Sent: 19/12/2022 5:54:29 PM
Subject: Re DA Application DA 2022/1128
Attachments: KEY Note 38 the Drive [191222].pdf;

Re: 38 The Drive, Freshwater DA 2022/1128

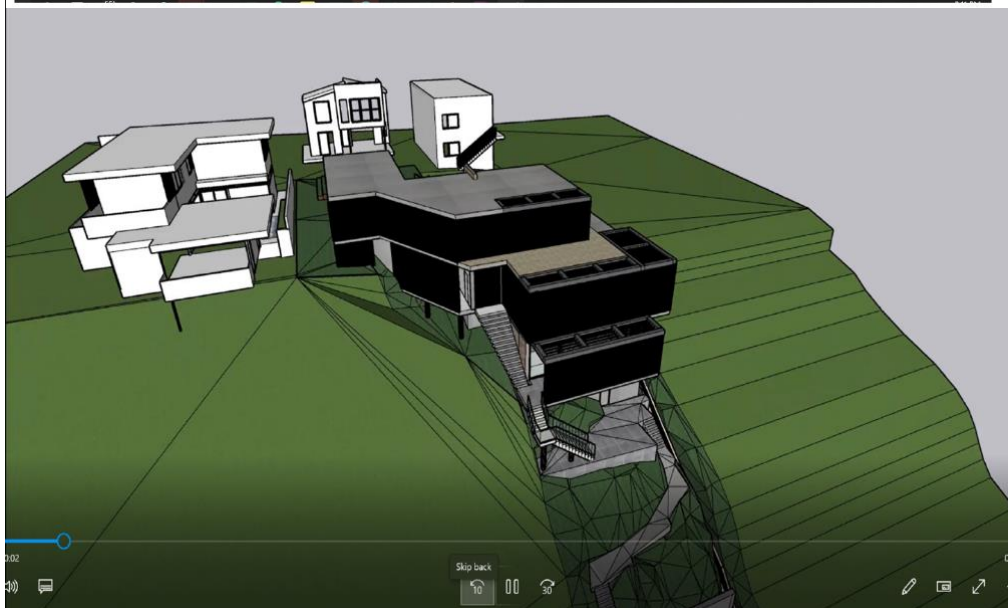
IT IS ALSO NOT BY ACCIDENT THAT THE APPLICANTS CHOOSE TO SHOW AN EASTERLY VIEW OF THE HOMES HERE AND I ENCOURAGE COUNCIL TO REVIEW NORTH AND SOUTH VIEWS TO TRULY DEMONSTRATE THE MASSIVE BULK, SCALE AND IMPINGEMENT ON OUR PROPERTY HE IS PROPOSING.

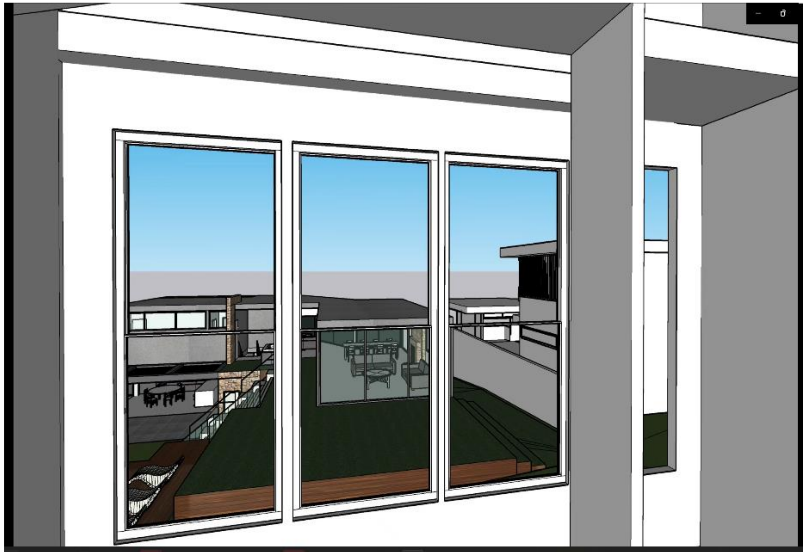
Compliant CDC which can be achieved by 38 The Drive IT IS UNCLEAR WHAT THIS IS INTENDED TO CONVEY? HAS THIS BEEN SURVEYED , MEASURED, PLANS PREPARED OR IS IT SOME KIND OF ISOLATED IMAGE? IS THE APPLICANT TRYING TO SUGGEST THAT IF THEY DON'T GET THEIR WAY WITH THE CURRENT DA APPLICATION THEY INTEND TO 'PUNISH' OTHER RESIDENTS WITH AN EVEN BIGGER BUILD, AN EXTRA ADDITION TO WHAT THEY ARE PRESENTLY PROPOSING? COUNCIL HAS ALREADY REJECTED AN ADDITIONAL UPPER FLOOR? ARE THEY PROPOSING NOT HAVING THE POOL? HOW DOES THIS DEMONSTRATE CONSIDERATION FOR ANY OF THE CONCERNS RAISED BY NEIGHBOURS OR COUNCIL , IT REMAINS UNCLEAR AS TO ITS PURPOSE OR RELEVANCE TO THE CURRENT DA UNDER CONSIDERATION, OTHER THAN TO REINFORCE A POSSIBLE PHILOSOPHY OF THE APPLICANT SEEKING TO HAVE AS BIG A DEVELOPMENT APPROVED AS POSSIBLE AND TO ONLY ADDRESS OBJECTIONS IN AN INCREMENTAL AND MINIMAL WAY, IF ABSOLUTELY FORCED TOO, IRRESPECTIVE OF ANY NEIGHBOUR'S LEGITIMATE CONCERNS.

View of proposed DA at 38 The Drive from 9 Lodge Lane

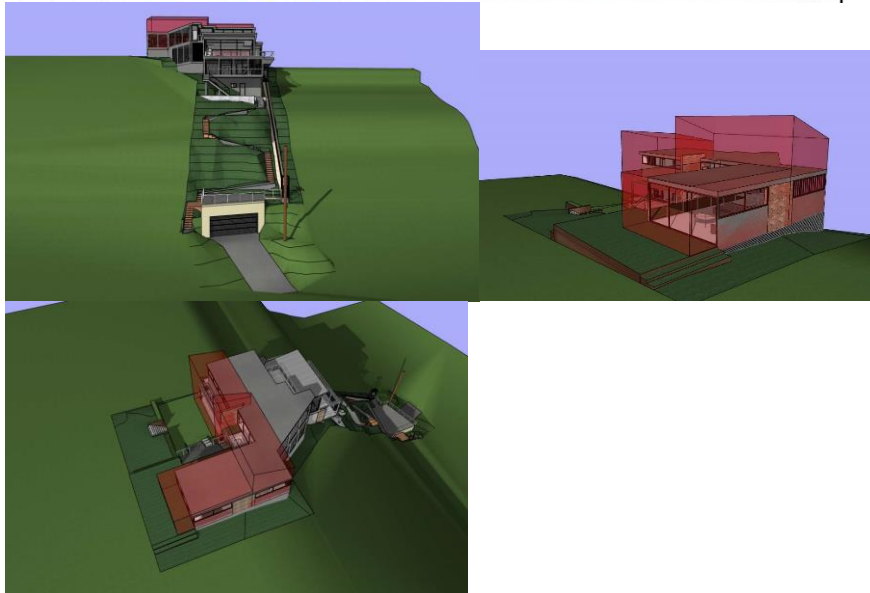
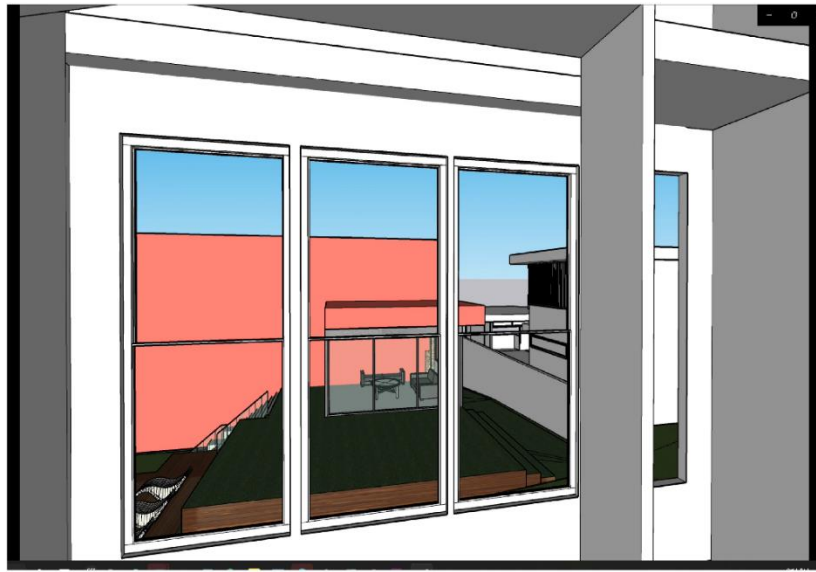
AGAIN IT REMAINS UNCLEAR WHAT THIS MODEL HAS TO THE PURPOSE OR RELEVANCE TO THE CURRENT DA UNDER CONSIDERATION, OTHER THAN TO REINFORCE A POSSIBLE PHILOSOPHY OF THE APPLICANT SEEKING TO HAVE AS BIG A DEVELOPMENT APPROVED AS POSSIBLE AND TO ONLY ADDRESS OBJECTIONS IN AN INCREMENTAL AND MINIMAL WAY, IF ABSOLUTELY FORCED TOO.
